Intel[®] I/O Controller Hub 10 (ICH10) Family

Specification Update

May 2012

Figure 2-1. Intel® ICH10 Interface Signals Block Diagram

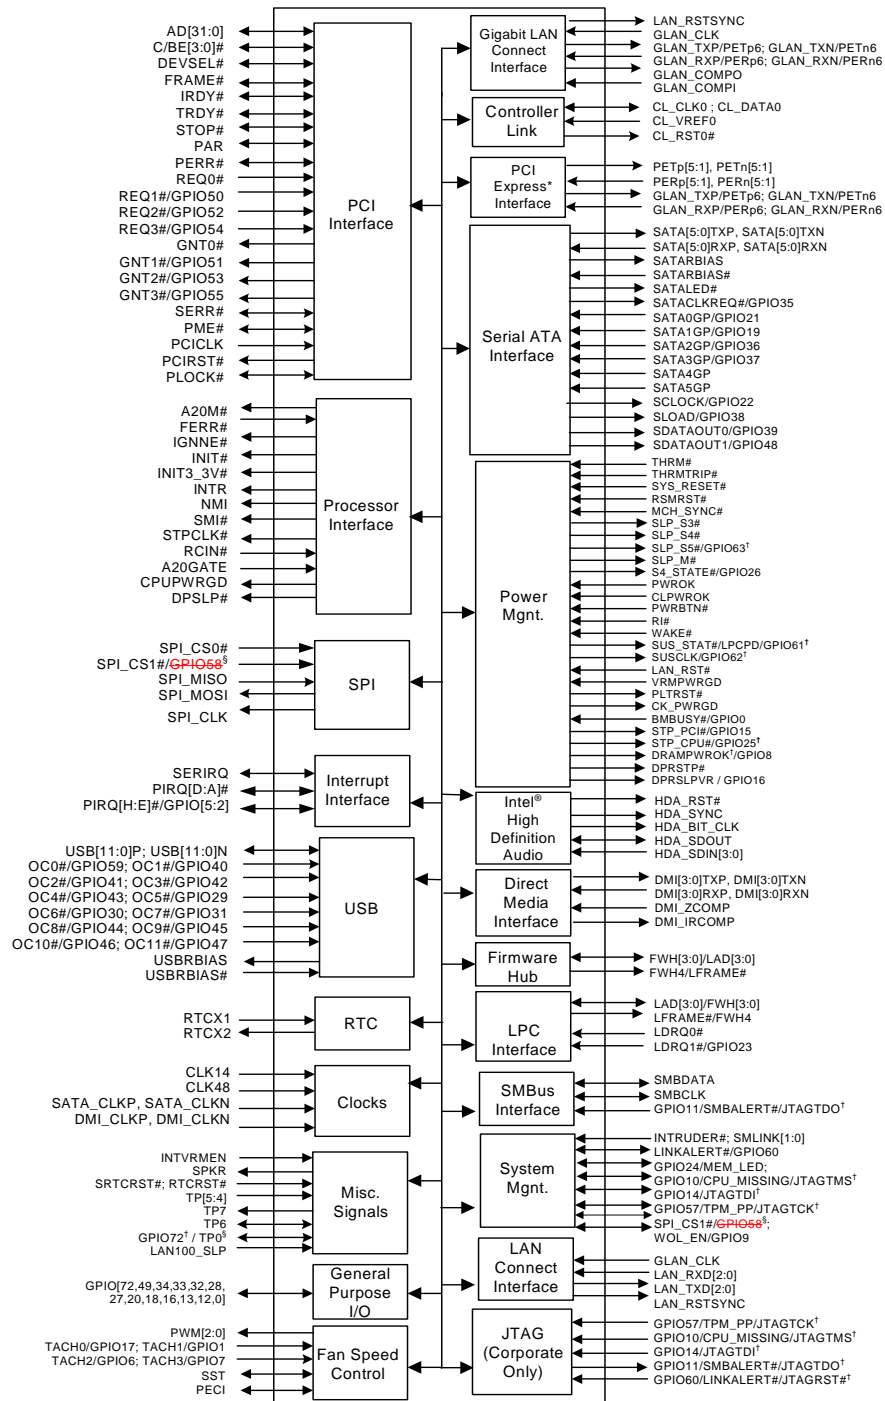
9. Remove GPIO58 from Figure 2-1, Intel® ICH10 Interface Signals Block Diagram

Update the following block diagram in Section 2, Signal Description, in the Datasheet.
